**HISTORIC PRESERVATION REVIEW BOARD
STAFF REPORT AND RECOMMENDATION**

Landmark/District: **Georgetown Historic District** (x) Consent
Address: **3107 N Street NW**

Meeting Date: **November 20, 2014** (x) Addition
Case Number: **15-037**

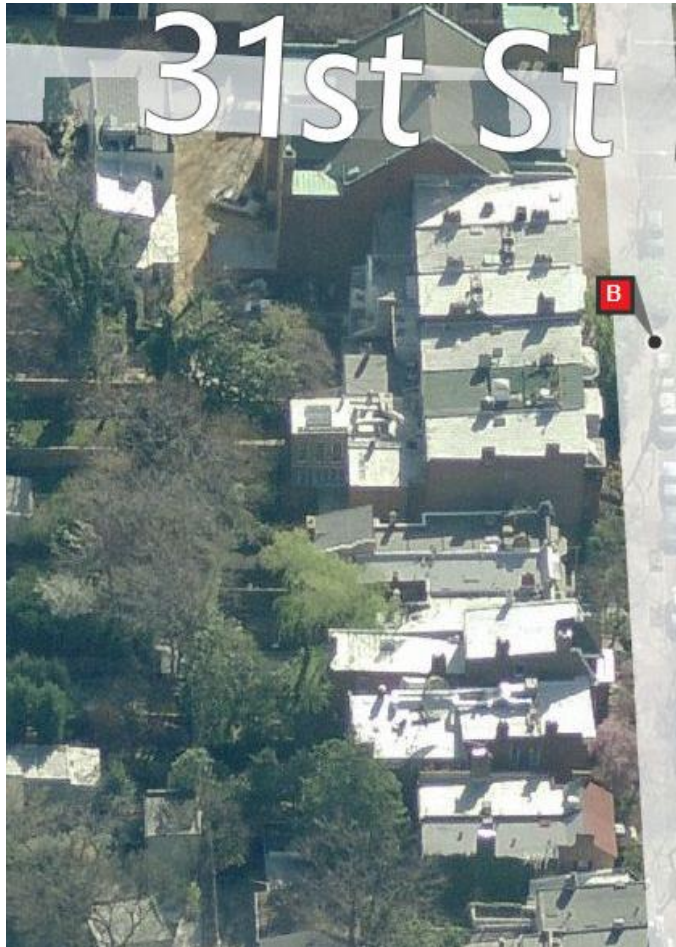
from the next-door Georgetown Baptist Church, built in 1899. The congregation is concerned about excavation next to their side wall—which supports a very heavy pipe organ—and to the covering of an original window opening in that wall that now contains a kitchen vent (see photograph below). These are both justifiable practical concerns, but the engineering and inspection of the basement and its footings and the operations necessary for excavation and construction are properly issues for the applicant to coordinate with the Department of Consumer and Regulatory Affairs (DCRA) and the neighbors. As for the side window/vent, that particular basement window cannot be considered an important character-defining feature given its location in the rear, within a common brick wall that has little to do with the fine brick and stone masonry of the church’s Romanesque facades. Neighbors on both sides of a common property line are entitled to reasonable use and enjoyment of their properties, including expansion when it is appropriate. They do not necessarily possess the right to vent into or see across a neighbor’s lot. DCRA treats openings located on common property lines as “at-risk,” i.e., subject to closure for reason of fire separation when new construction would abut them.
